Existing Site Plan (Scale 1/500)

Drg N° TMM / DC / 04

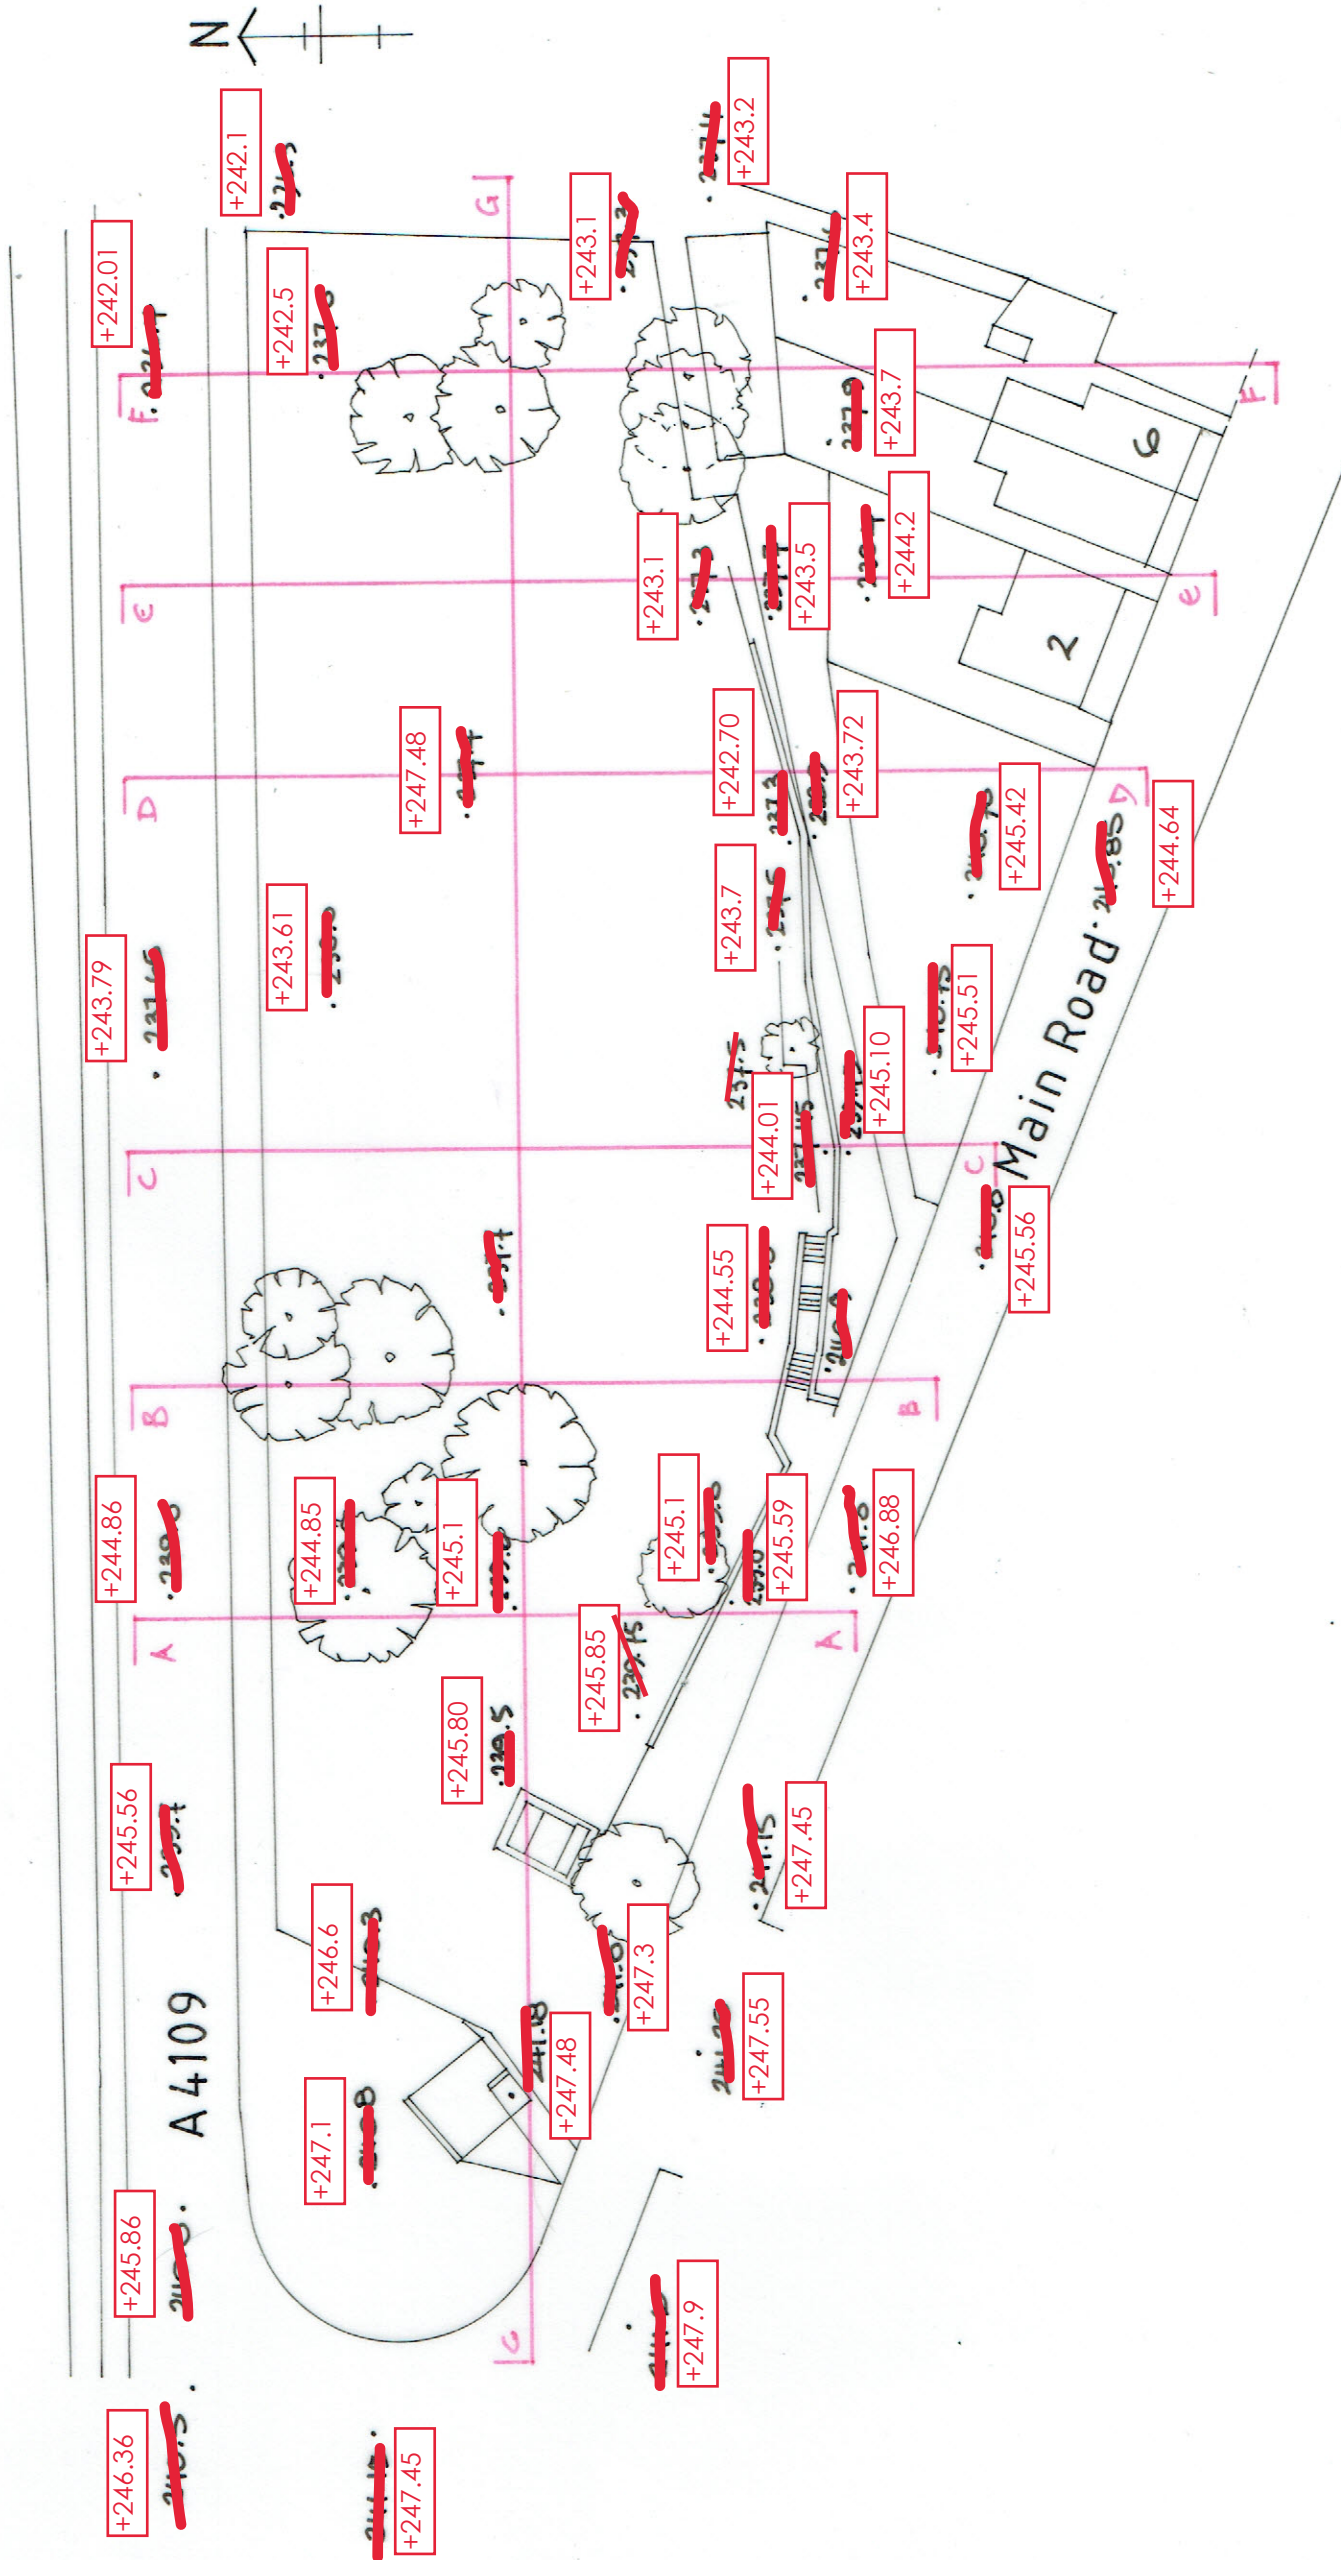
Heights shown in red have been amended by Hickman and Smith Architects due to discrepancies in the original topographic survey. See submitted document 0346-A-RP-001-Planning Comparison CD for further explanation.

Please also refer to updated site plan 0356-A-PL-100-A
